**Subject:** Class 2 Permit Modification Request, Waste Isolation Pilot Plant Hazardous Waste Facility Permit Number: NM4890139088-TSDF

- Addition of Four New Shielded Containers
- Revise Site Recertification Audit Scheduling from Annual to Graded Approach

**Class 2 Permit Modification Request**  
**Addition of Four New Shielded Containers**  
**and**  
**Revise Site Recertification Audit Scheduling from Annual to Graded Approach**  
**Waste Isolation Pilot Plant**  
**Carlsbad, New Mexico**  
**WIPP Permit Number - NM4890139088-TSDF**

**April 2024**

**Figure M-11**  
**Range of Typical Shielded Container Dimensions**

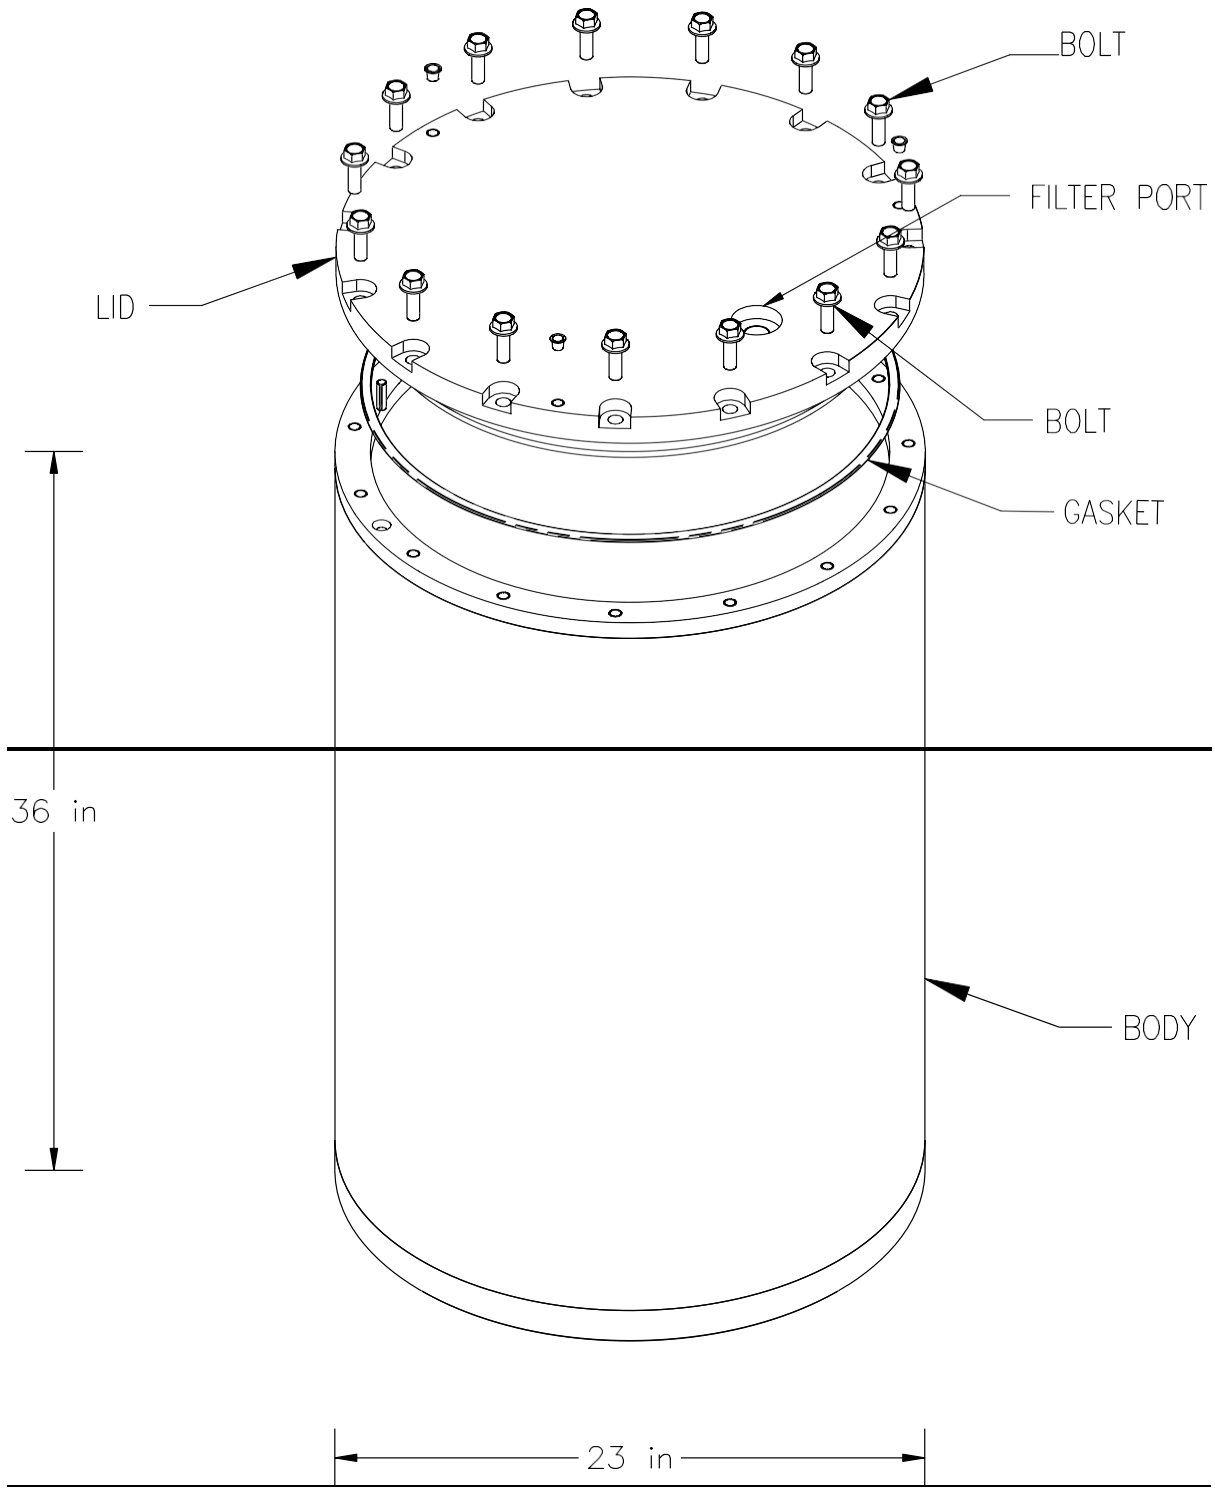
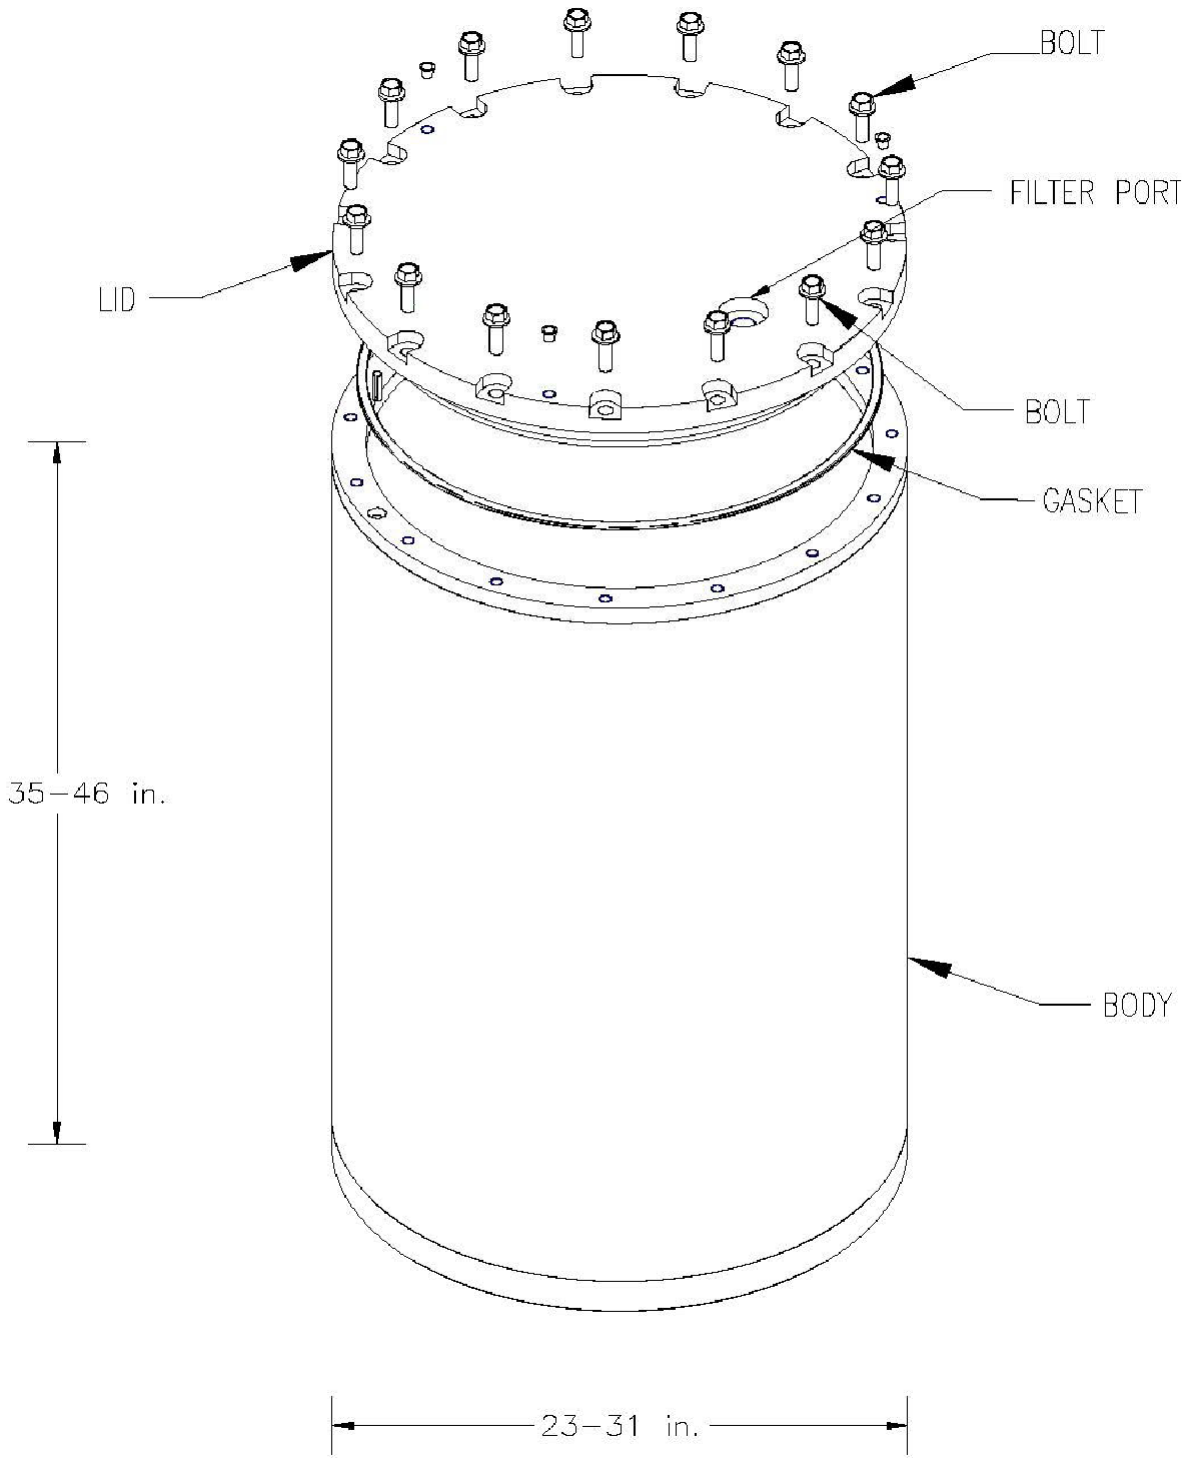
- Revised Permit Attachment M, Figures, Figure M-11, *Typical Shielded Container*, to update the figure to a range of dimensions and update the figure title.

<p>Attachment E, Table E-1, <i>Inspection Schedule/Procedures</i></p>	<p>Added new line for "SCA Handler" inspection with the following specific information: added "SCA" to the System/Equipment Name column, "Waste Operations" to Responsible Organization column, "Preoperational" to Inspection Frequency column, and the "WP-05-WH1450 Inspecting for Mechanical Operability<sup>m</sup> and Deterioration<sup>b</sup> to the Procedure Number and Inspection Criteria<sup>h</sup> column.</p>
<p>Attachment M, <i>Figures, List of Figures</i></p>	<p>Modified the language for Figure M-11 from: "Typical Shielded Container" to: "Range of Typical Shielded Container Dimensions"</p>
<p>Attachment M, <i>Figures, Figure M-11, Typical Shielded Container</i></p>	<p>Modified the language on Figure M-11 from: "Typical Shielded Container" to: "Range of Typical Shielded Container Dimensions"</p>

<b>Affected Permit Section</b>	<b>Explanation of Change</b>
	Replaced the vertical measurement of "36 in" with "35-46 in"
	Replaced the horizontal measurement of "23 in" with 23-31 in"
